ST. CHARLES SINCE 1834	**PLAN COMMISSION AGENDA ITEM EXECUTIVE SUMMARY**			
	Project Title/ Address:	The Quad St. Charles/Charlestowne Mall PUD- PUD Preliminary Plan and Final Plat of Subdivision		
	City Staff:	Russell Colby, Planning Division Manager		
	Please check appropriate box (x)			
	PUBLIC HEARING		**MEETING 3/18/14**	X

RE: The Quad St. Charles (Charlestowne Mall PUD) – Site Plan, Preliminary Engineering Plan and Final Plat of Subdivision for Theater Building

DATE: March 14, 2014

Approved Concept Site Plan with locations of changes:

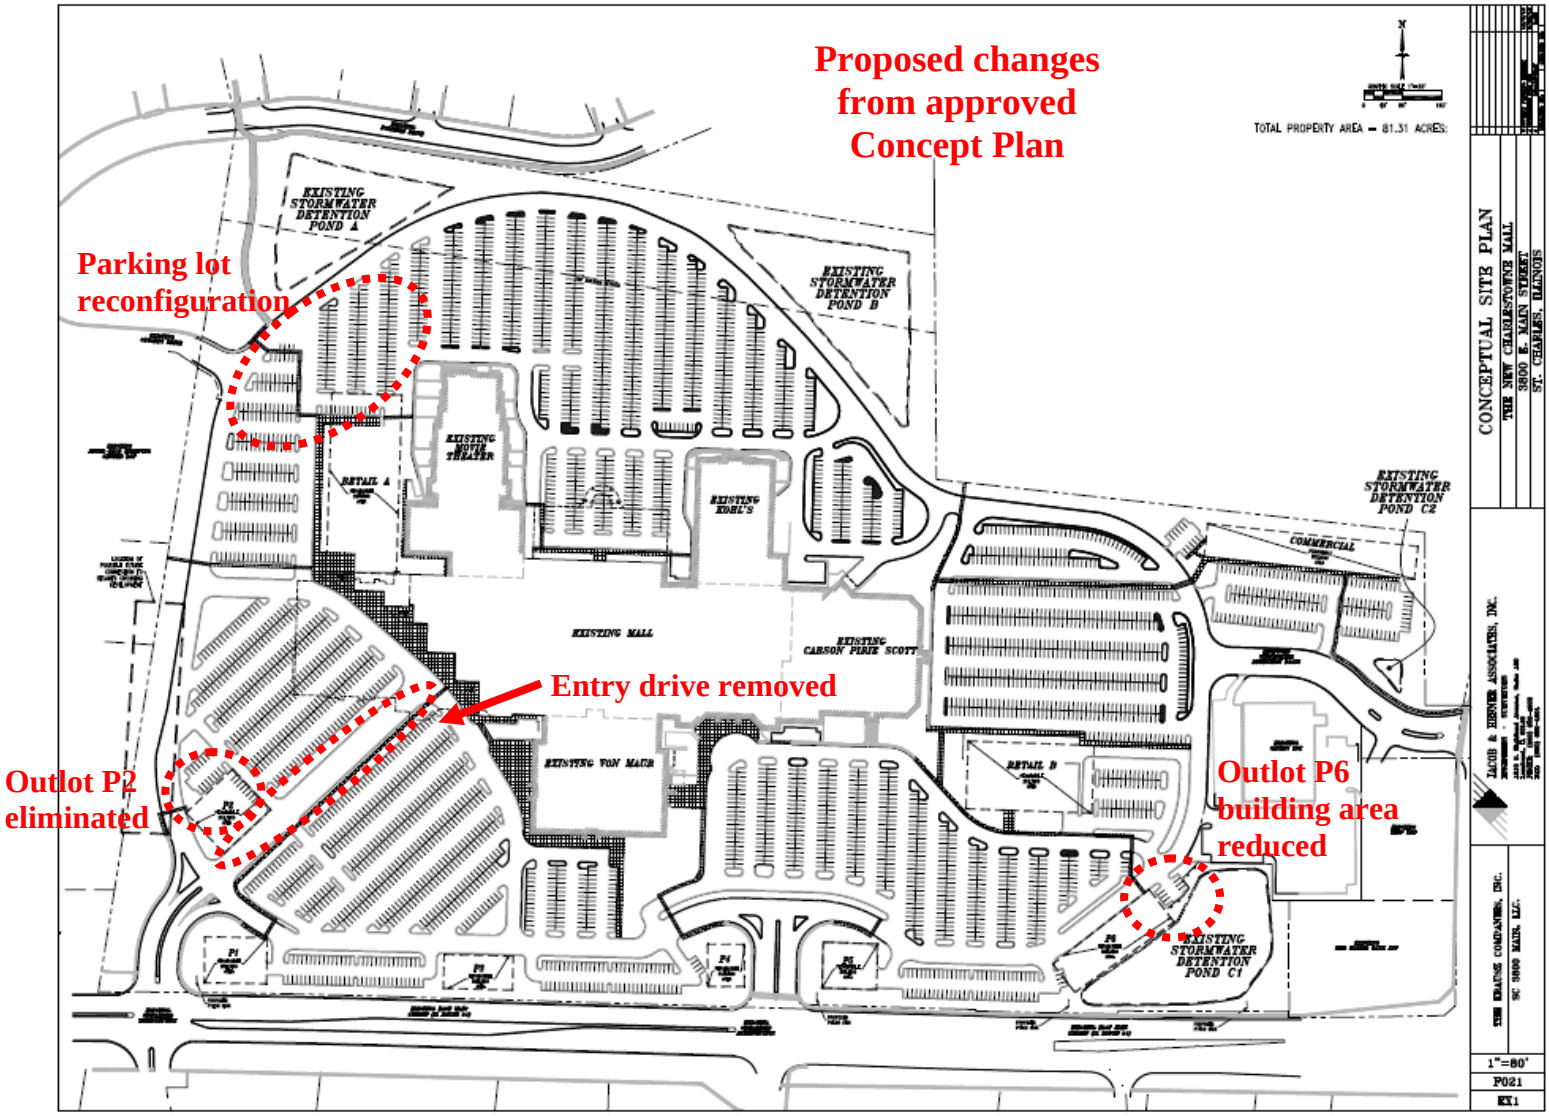
The overall site layout is substantially similar to the Concept Site Plan that was approved with the PUD ordinance. Changes to the site plan:

- Outlot building footprints and parking lots have been omitted from this plan, as these will be reviewed and approved later.
- Outlot building site P2, which was located inside the ring road at the southwest corner of the property, has been removed.
- The entry drive from the southwest entrance/ring road intersection to the mall building has been removed.
- Some areas of the parking lot have been slightly reconfigured.
- The permissible building area identified for outlot P6 adjacent to pond C1 has been reduced.
